Comments are highlighted in blue and responses are provided directly after each comment.

Impact of climate change on water resources in a tropical West African catchment using an ensemble of climate simulations

Yacouba Yira¹, Bernd Diekkrüger¹, Gero Steup¹, Aymar Y. Bossa^{2,3}

Fig. 6 Historical RCMs-GCMs based discharge simulations and observation based discharge: (a) all RCM rainfall are bias corrected, (b) simulated discharge with bias corrected and not bias corrected rainfall data are compared for CCLM-ESM.

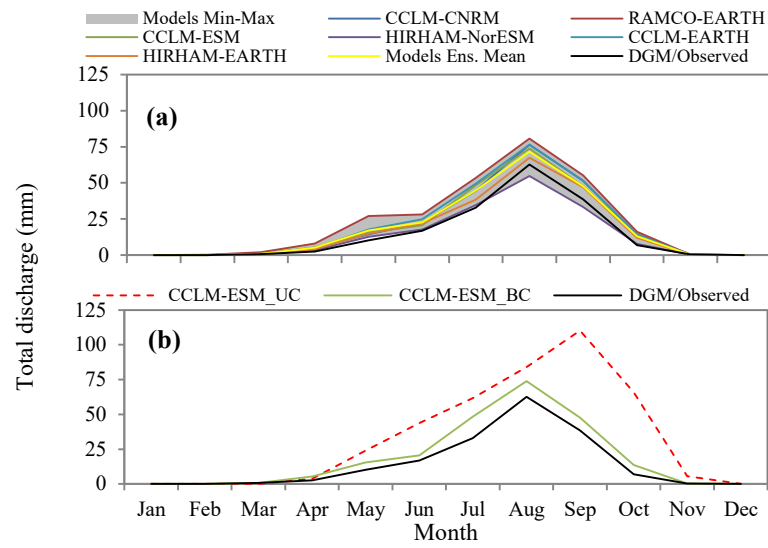
5. In the Discussion the authors state: p.12, 362ff: " In the view of the general good simulation of historical discharge for the climate models ensemble, it is worth noting that running the hydrological model with simulated climate data of one node (...) has reasonably bridged the discrepancy between RCMs-GCMs data resolution and hydrological modeling domain. Therefore, the approach can be considered as eligible for climate change impact assessment for small scale catchments."

If I understood the methodology correctly, there were no hydrological measurement data available for the historical period, so the runoff, which was simulated with the input data from one weather station, was compared to the runoff simulated with one node of the bias-corrected historical runs of the GCMs-RCMs. As the bias correction for the climate models was carried out using this weather station data, the hydrological input data certainly turn out to be very similar as they have been adjusted by the bias correction (by definition!). Hence, this "proof" seems to me redundant and not convincing.

It has to be pointed out that; the "one node at a time" method is referred to be an approach for CC impact assessment for small catchments in which interpolation methods create issues related to the representation of climate variables (particularly precipitation). This section was modified in the manuscript ([see L380-388](#)). In regions with higher data availability, historical

RCM-based discharges should necessarily be compared to historical observed discharge, which could not be done in the current study.

Fig. 7 Monthly discharge change between the reference period (1971-2000) and the future period (2021-20150) under emission scenarios RCP4.5 and RCP8.5. *UC* refers to not bias corrected.

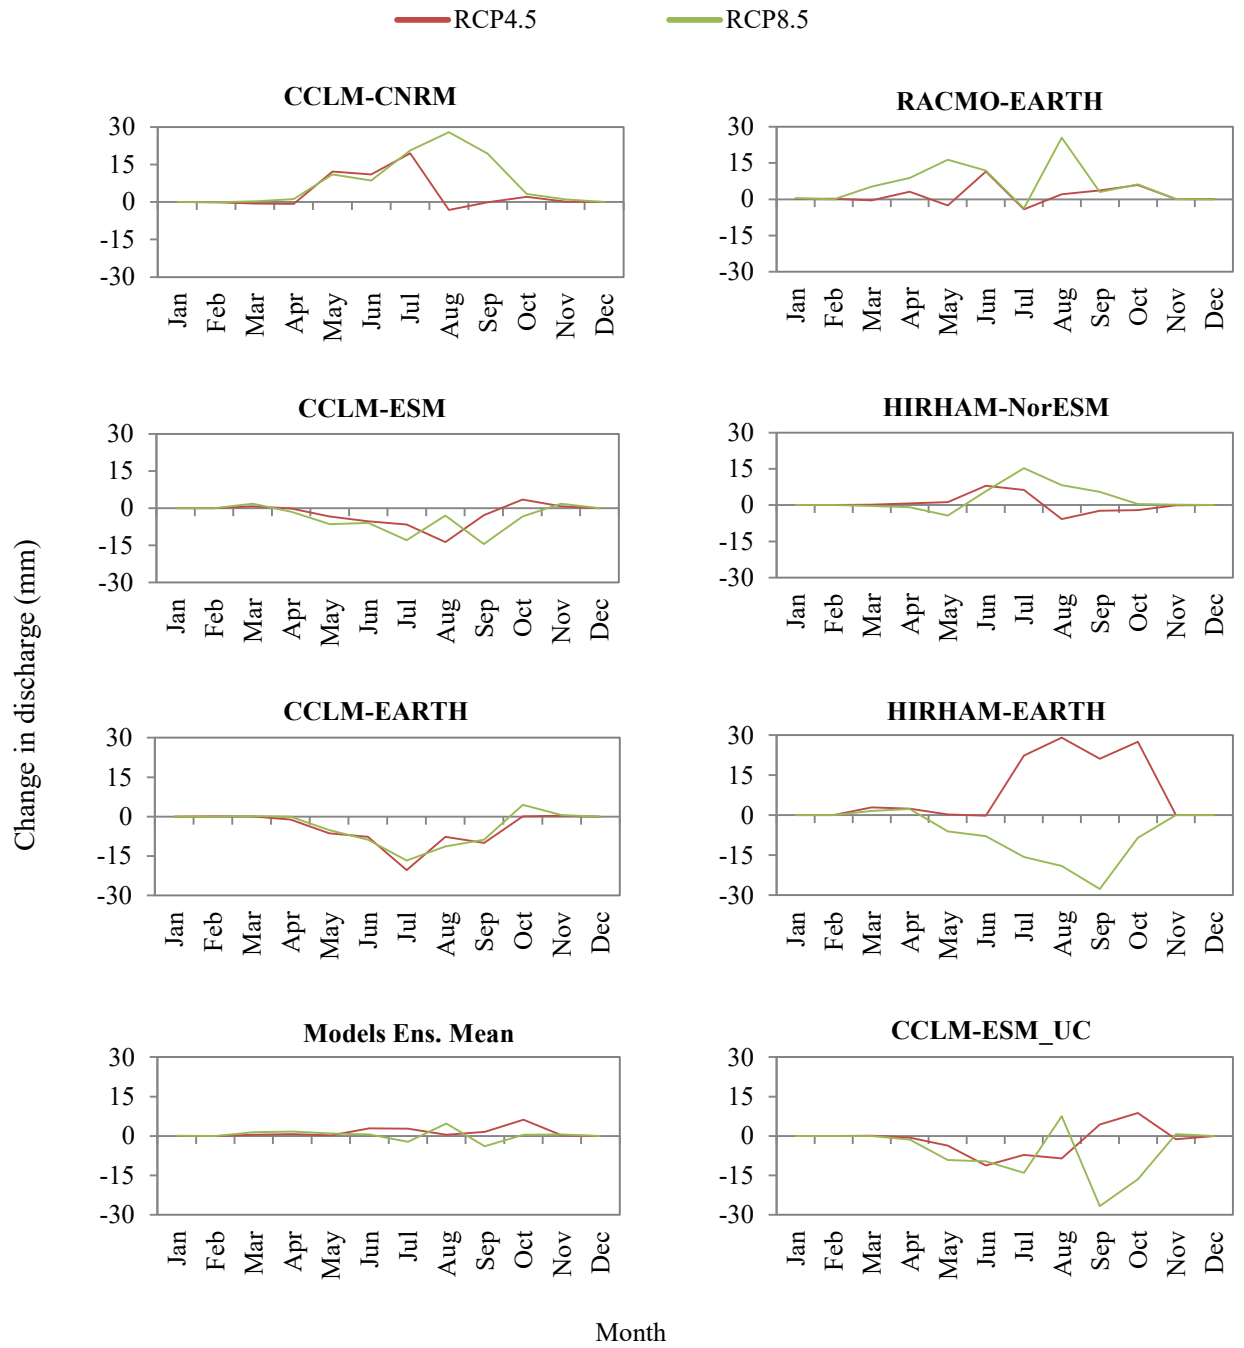
p. 9, L. 268: "The intra-annual change in discharge appears strongly determined by the precipitation change signal (Fig. 8)." Fig. 8 shows monthly discharge changes but not the reason for these changes. Reasons for these changes in discharge could also be e.g. higher evaporative demand due to higher temperatures.

This was corrected to "The intra-annual change in discharge (Fig. 8) appears strongly determined by the precipitation change signal (Fig. 6)". (Please see L277-278).
